Project	<b>IEEE 802.16 Broadband Wireless Access Working Group</b> < <a href="http://ieee802.org/16">http://ieee802.org/16</a> >	
Title	<b>DL and UL loading parameters information</b>	
Date Submitted	<b>2007-03-13</b>	
Source(s)	Peretz Feder – Alcatel-Lucent Phillip Barber - Huawei Honghai Zhang – Alcatel-Lucent	<a href="mailto:pfeder@alcatel-lucent.com">pfeder@alcatel-lucent.com</a> <a href="mailto:pbarber@broadbandmobiletech.com">pbarber@broadbandmobiletech.com</a> <a href="mailto:hozhang@alcatel-lucent.com">hozhang@alcatel-lucent.com</a>
Re:	IEEE 802.16 Session #48	
Abstract	This contribution proposes the updates of IEEE 802.16g D8 document in order to obtain loading information from the Base Station	
Purpose	Update 802.16g draft obtain uplink and downlink loading information	
Notice	This document has been prepared to assist IEEE 802.16. It is offered as a basis for discussion and is not binding on the contributing individual(s) or organization(s). The material in this document is subject to change in form and content after further study. The contributor(s) reserve(s) the right to add, amend or withdraw material contained herein.

## **DL and UL loading parameters information**

Figure 57 – Maintaining downlink synchronization

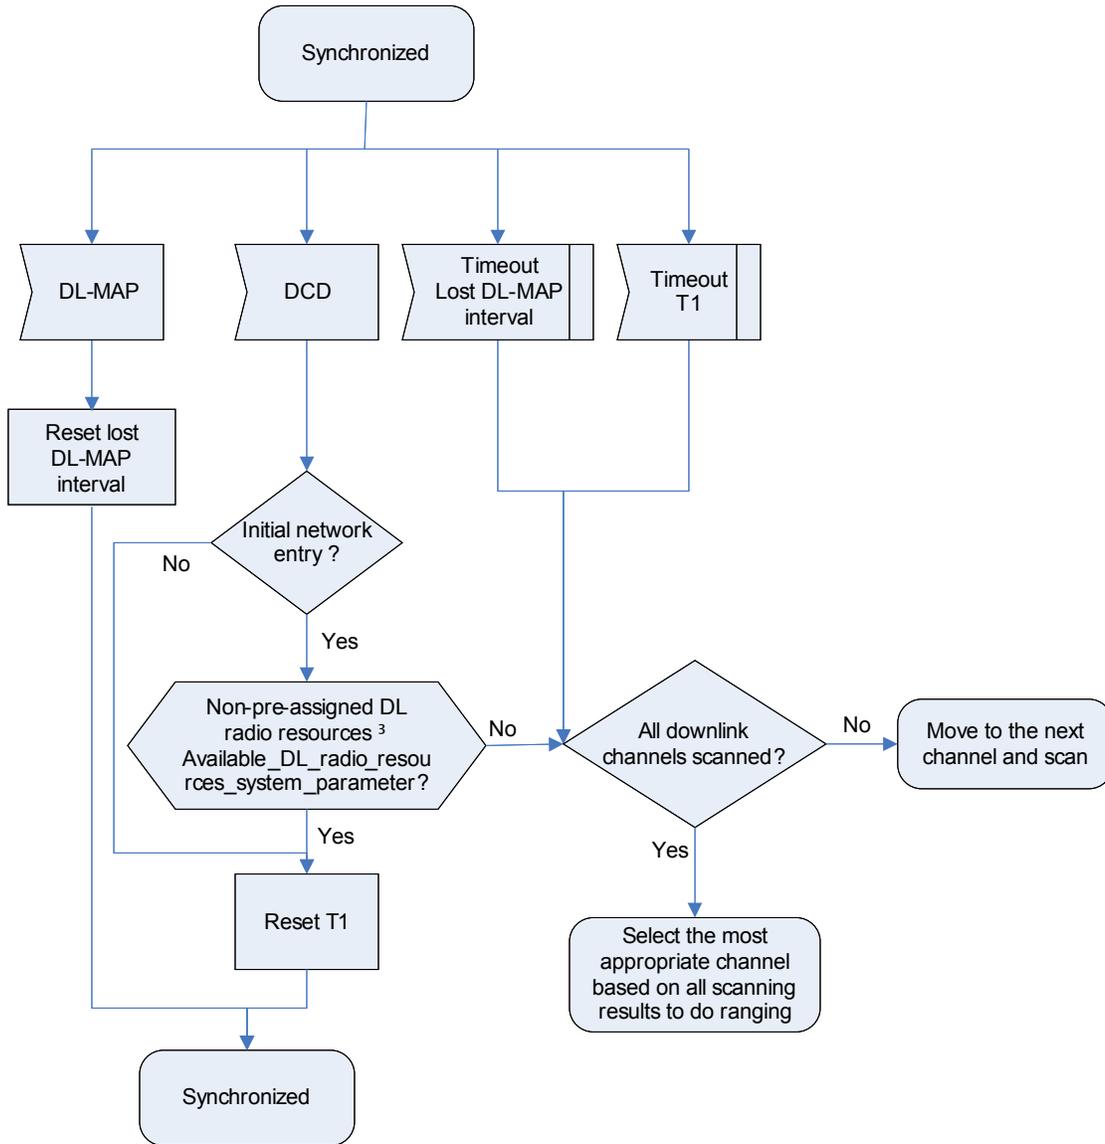
The MAC shall search for the DL-MAP MAC management messages. The SS achieves MAC synchronization once it has received at least one DL-MAP message and is able to decode the DL-Burst Profiles contained therein. An SS MAC remains in synchronization as long as it continues to successfully receive the DL-MAP and DCD messages for its channel **upon network entry only** and the Non-pre-assigned DL radio resources in the DCD message are higher than or equal to the available\_DL\_radio\_resources\_system\_parameter. If the reported Non-pre-assigned DL radio resources are less than the available\_DL\_radio\_resources\_system\_parameter, the SS/MS should continue scanning to find another channel until all channels are scanned. If all channels are scanned, the MS should choose the most appropriate channel to perform initial ranging according to section 6.3.9.5 based on conditions that include **RSSI**, CINR and the available Non-pre-assigned DL/UL radio resources of all channels. If the Lost DL-MAP Interval (Table 342) has elapsed without a valid DL-MAP message or the T1 interval (Table 342) has elapsed without a valid DCD message, an SS shall try to reestablish synchronization. The process of acquiring synchronization is illustrated in Figure 56. The process of maintaining synchronization is illustrated in Figure 57. (language change: add MS and SS section to explain better – perform MAC HO function 6.3.25 or 22?. SS initial entry )

(Note to Editor: Need to modify Figure 57 – see below)

Figure 58 – Obtaining uplink parameters

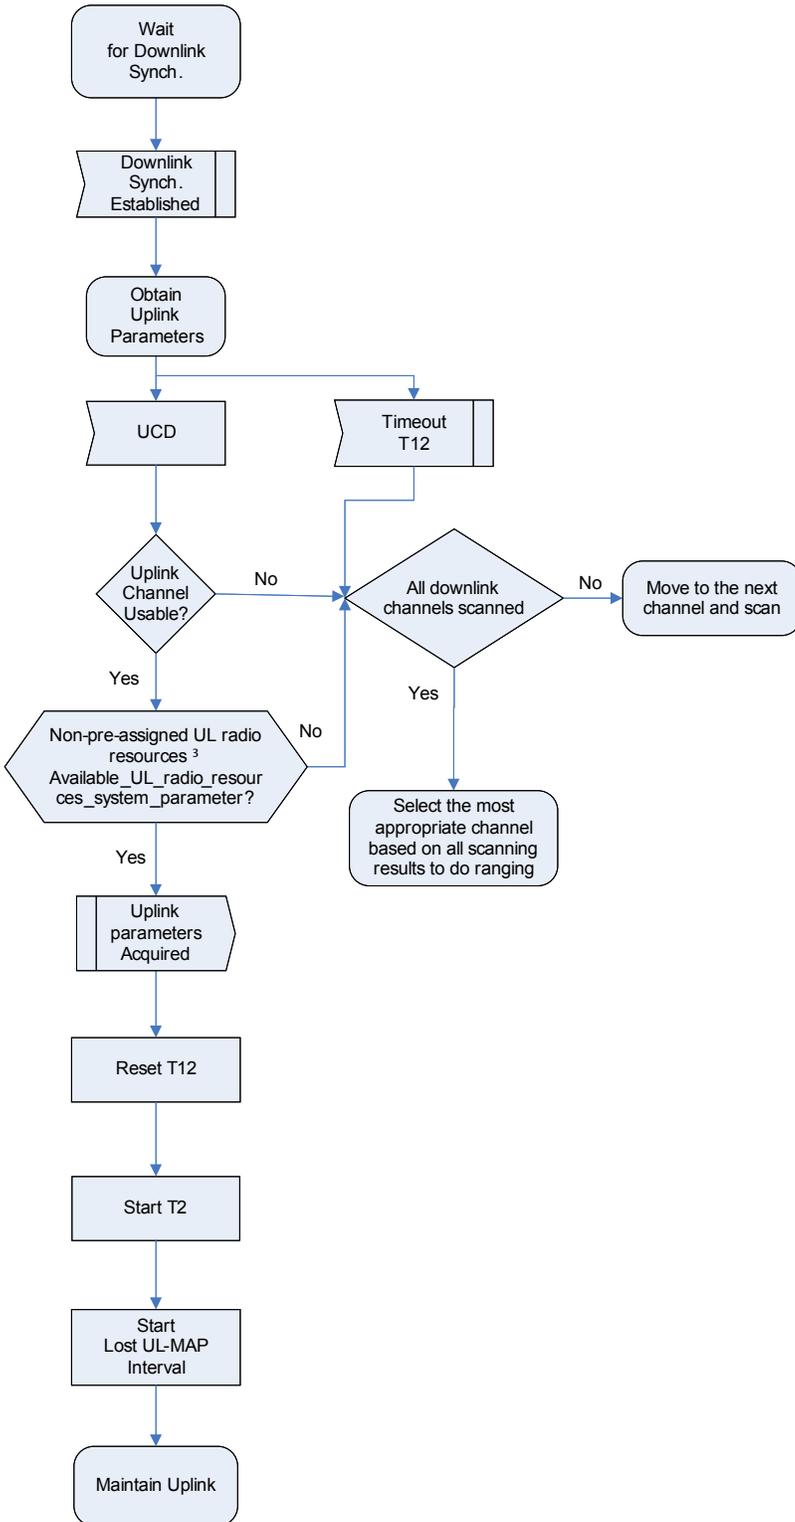
If no uplink can be found after a suitable timeout period, **or if the Non-pre-assigned UL radio resources in the UCD message are lower than the available\_UL\_radio\_resources\_system\_parameter**, then the SS shall continue scanning to find another downlink channel. The process of obtaining uplink parameters is illustrated in Figure 58. (Editor: need to change Figure 58 – see below)

The SS shall determine from the channel description parameters whether it may use the uplink channel. If the channel is not suitable **or the Non-pre-assigned UL radio resources are lower than the available\_UL\_radio\_resources\_system\_parameter**, then the SS shall continue scanning to find another downlink channel. If the channel is suitable, the SS shall extract the parameters for this uplink from the UCD. Then, the SS shall wait for a bandwidth allocation map for the selected channel. It may begin transmitting

Figure 59 – Maintain uplink parameters

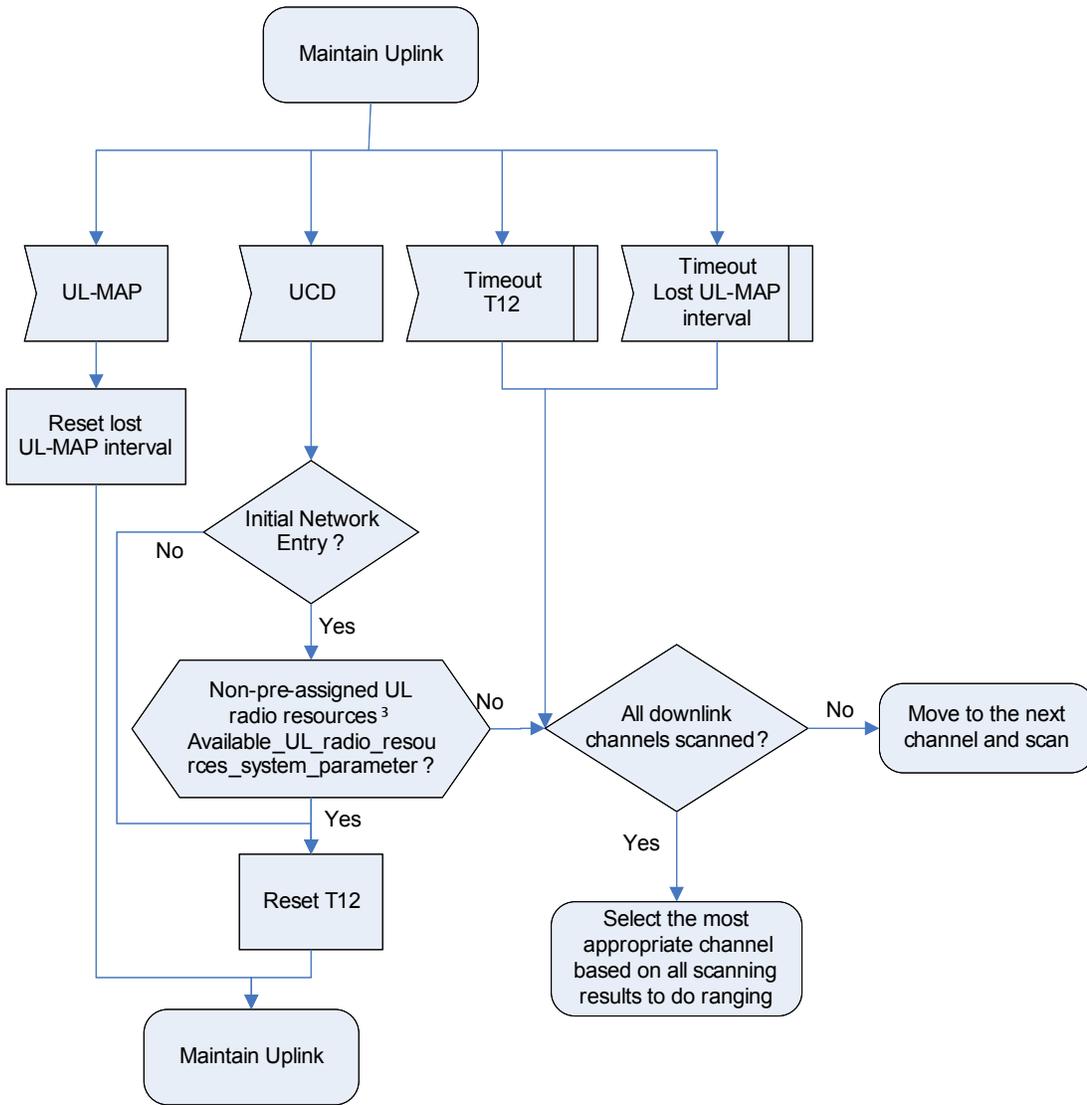
The SS MAC is considered to have valid uplink parameters as long as it continues to successfully receive the UL-MAP and UCD messages. If at least one of the messages is not received within the time intervals specified in Table 342 or the Non-pre-assigned UL radio resources are lower than the `available_UL_radio_resources_system_parameter`, the SS shall not use the uplink. This is illustrated in Figure 59.

(Editor: need to change Figure 59 – see below)
